Airplane and Engine Certification Requirements in Supercooled Large Drop, Mixed Phase, and Ice Crystal Icing Conditions; Final Rule

[Docket No. FAA-2010-0636; Amendment Nos. 25-140 and 33-34]

Airplane and Engine Certification Requirements in Supercooled Large Drop, Mixed Phase, and Ice Crystal Icing Conditions**AGENCY:** Federal Aviation Administration (FAA), DOT.**ACTION:** Final rule.

FIGURE 1 — Appendix O, Freezing Drizzle, Liquid Water Content

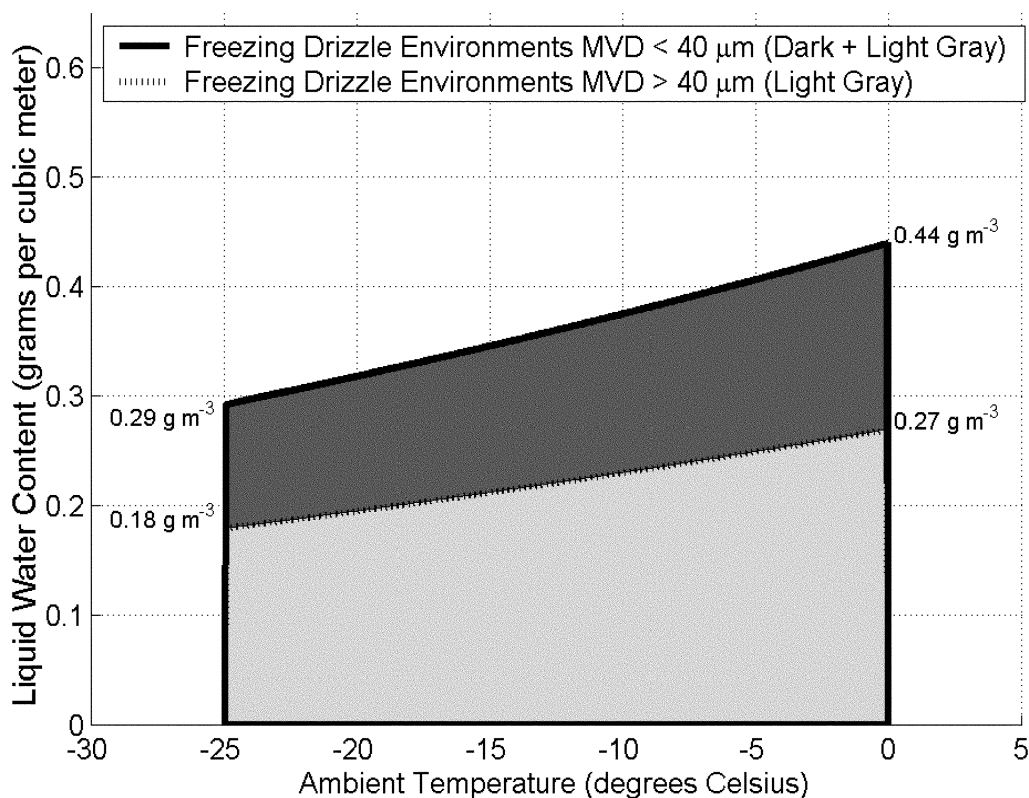
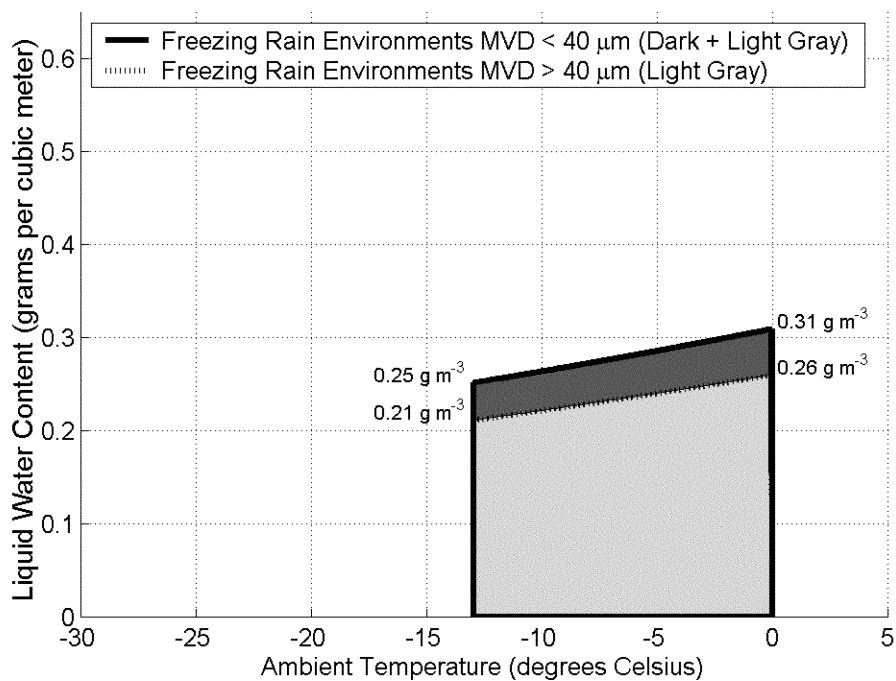
In response to other comments, figures 1 and 4 of appendix O have been revised in this final rule to reflect the LWC proposed by the IPHWG. As a result, freezing drizzle conditions with a median volume diameter (MVD) greater than 40 microns fall within the adverse region that would be identified using the University of Wyoming LWC/drop size technique. No changes to appendix O were made as a result of these comments.

Several commenters said that proposed figures 1, 4, and 7 in appendix O of the NPRM were different than what was proposed by the IPHWG, and that the FAA did not provide an explanation for those differences. The commenters also noted that the higher LWC contained in the figures proposed in the NPRM could have a significant impact on an applicant's design. GSIS specifically noted that the higher water content defined in appendix O will have

We agree. We reviewed the figures proposed in the NPRM and the data used by the IPHWG to generate the figures. We revised figures 1 and 4 to reflect the lower water content values proposed by the IPHWG, but the water content in appendix O is still higher than within appendix C at the same temperature. The higher water content may increase the power requirements for some electro-thermal deicing system designs, but not to the extent that may have been necessary with the water contents proposed in the NPRM. The environmental conditions defined in appendix O are valid conditions that will need to be considered for applicable future designs. Our review of the data used to generate the scaling factor curve in figure 7 indicates that the figure 7 proposed by the IPHWG in the task 2 working group report was incorrect; ⁴ figure 7 in the NPRM was correct. Therefore, figure 7 in this final rule remains as proposed in the NPRM. Figures 1, 3, 4, and 6 of appendix O in this final rule have been revised to identify the corner data points for clarity.

FIGURE 6 — Appendix O, Freezing Rain, Temperature and Altitude

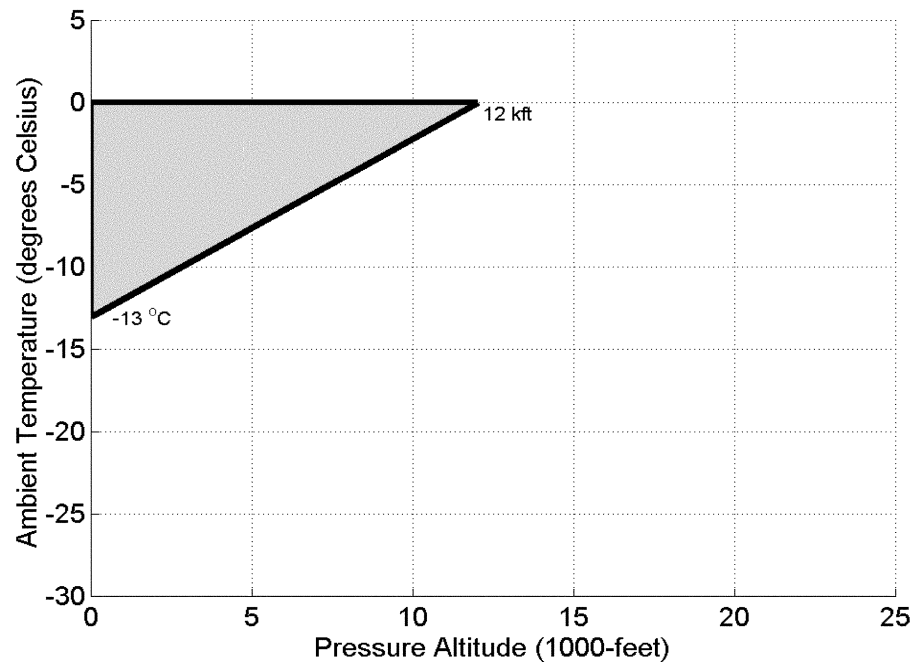
One commenter, a private citizen, noted that the NPRM did not identify the vertical extent for part 25, appendix O, figure 6. We disagree. The pressure altitude range and vertical extent for freezing rain were provided in appendix O, part I, paragraph (b) in the NPRM located under figure 3. We clarified appendix O, part I, by moving all of the general text describing the meteorological parameters, including vertical extent, ahead of the figures.

FIGURE D3 — Exposure Length Influence on TWC

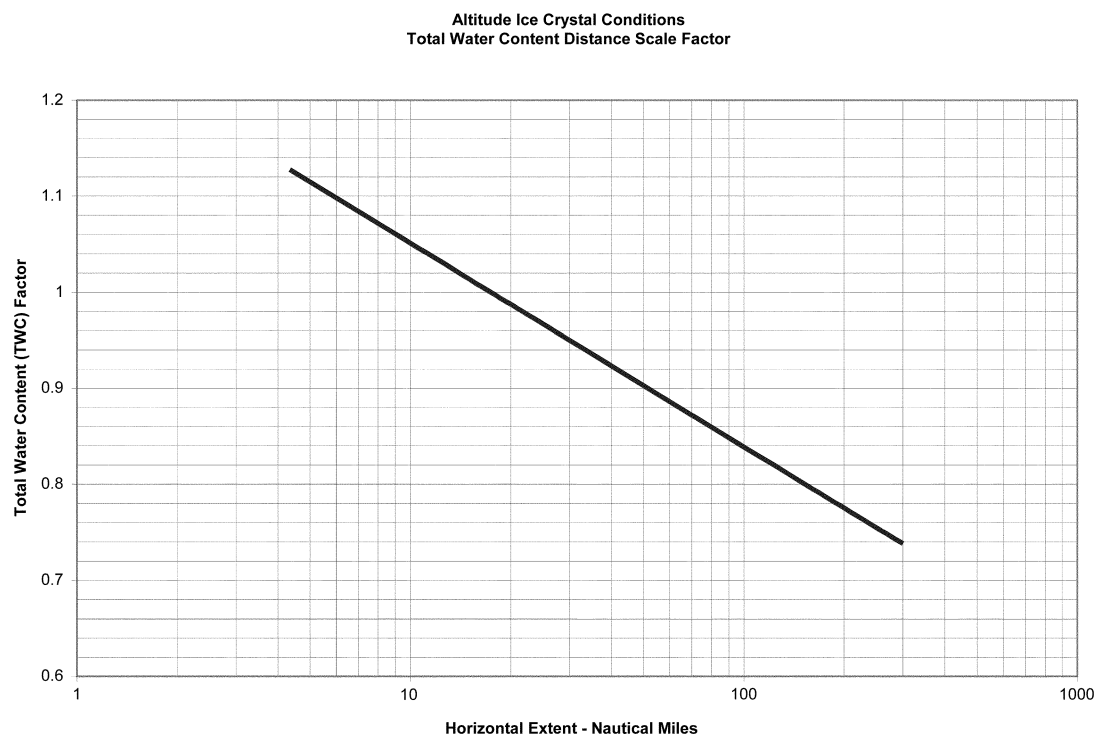
Snecma commented that the y-axis value in proposed part 33, appendix D, figure D3, was incorrect. The value should be 0.6 but the NPRM showed the value as zero.

33, appendix D, figure D3, to depict the correct axis values. The lowest x-axis value is now 1 and the lowest y-axis value is now 0.6.
